# UNITED STATES PATENT AND TRADEMARK OFFICE

10/785,672

Michael P. Whitman

<b>Office Action Summary</b>	<b>Application No.</b> 10/785,672	<b>Applicant(s)</b> WHITMAN ET AL.	
	<b>Examiner</b> GLORIA R. WEEKS	<b>Art Unit</b> 3721

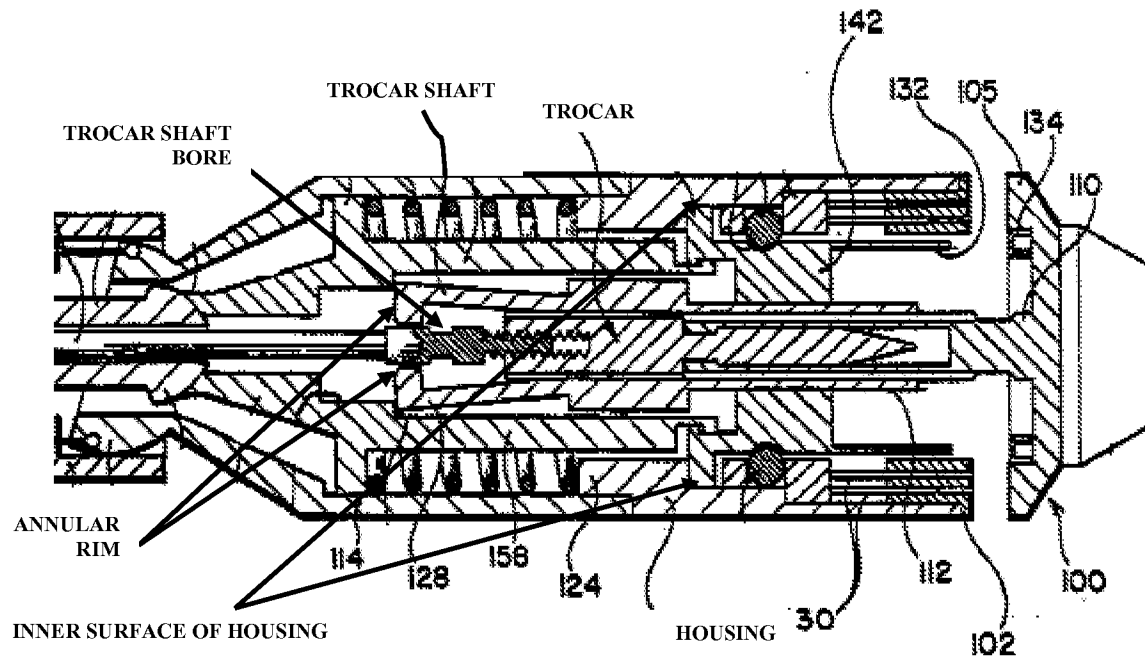
In reference to claims 100, 102-104 and 106-109, Grant et al. discloses a surgical device, comprising: a staple housing 104 receiving a stapler cartridge 102, the housing 104 having an inner surface defining a bore (*see diagram of Grant et al. figure 18 below*) ; a rim 112 extending radially inward from the inner surface 124 of the housing 104 (figure 9-column 11 lines 49-52); a trocar shaft 128 defining a longitudinally extending bore disposed through the bore of the housing 104 and extends distally<sup>1</sup> relative to a clamping face (figures 6-7), so as to be moveable relative to the housing 104 by operation of at least one driver 84 by a first rotatable drive shaft 96, wherein the at least one driver 84 is within the housing 104; and an anvil 100 attachable to the trocar shaft 128 and configured to be moveable relative to the housing by movement of the trocar shaft 128

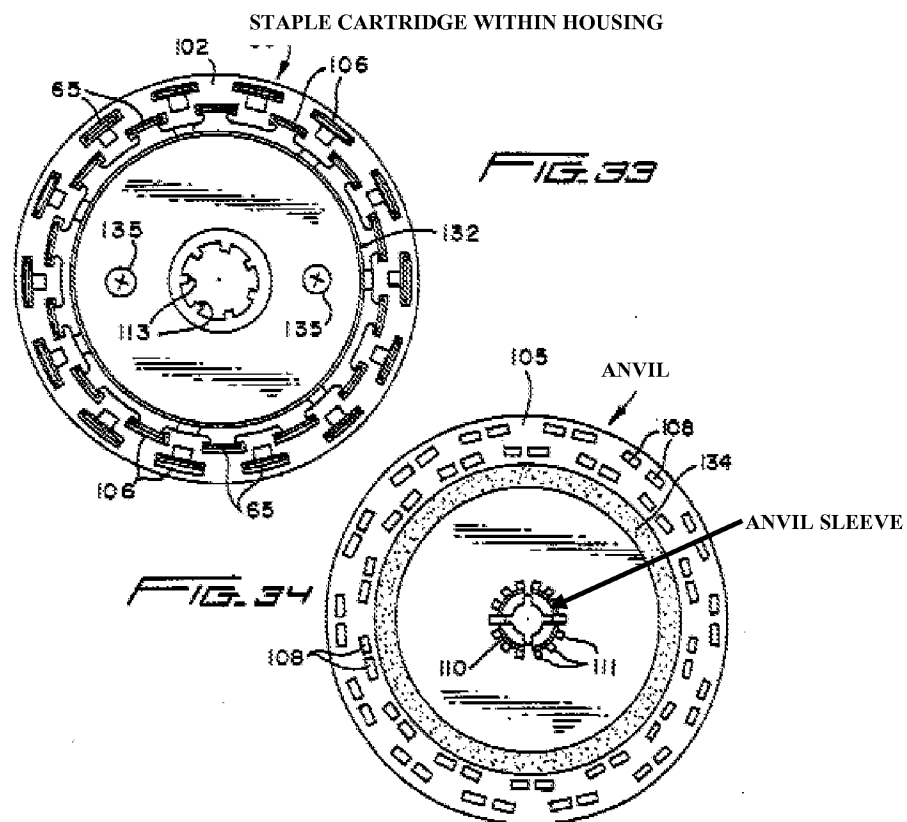
wherein the anvil 100 includes an anvil face 105 and an anvil sleeve 110 defining a trocar receiving slot (*see figure 34 diagram of Grant et al. below*) and the anvil sleeve 110 having at least a pair of axially extending slots 101 and a circumferential recess (defined by 111 segments-figure 34) receiving portion 113 of the rim 112 (column 13 line 64- column 14 line 14), wherein the anvil sleeve 110 is received within the bore of the trocar shaft (*see diagram above*); and a second driver 85 operable a second rotatable drive shaft 92 to drive staples from the staple housing 104.

Although Grant et al. discloses a plurality of recesses 111 that extend radially along the circumference of the anvil sleeve, wherein each recess receives an annular rim of the staples housing. Grant et al. does not disclose a single recess that extends radially around the anvil sleeve. Balazs et al. teaches a staple housing 30 including an inner surface having an annular rim 22 that extends radially within the housing ; and a sleeve 5 extending from an anvil 1, wherein the sleeve 5 has a recess 54 that extends radially around the circumference of the sleeve such that

the annular rim 22 is received within the recess 54. Grant discloses the annular rim configured to engage a recess of the flexible cable driver 84, wherein the driver 84 is secured as an assembly with the trocar and the anvil sleeve such that there is no relative movement thereof, whereby engagement of the annular rim with the recess prevents movement of the anvil sleeve longitudinally within the trocar shaft bore. It would have been obvious to one having ordinary skill in the art at the time of the invention to modify the anvil sleeve of Grant et al. to include a circumferential recess that receives a circumferential rim of the staple housing, since Balazs et al. suggests that such a modification would firmly secure the anvil sleeve axially relative to the inner surface of the staple housing, just as Grant has disclosed with respect to the anvil sleeve assembly.
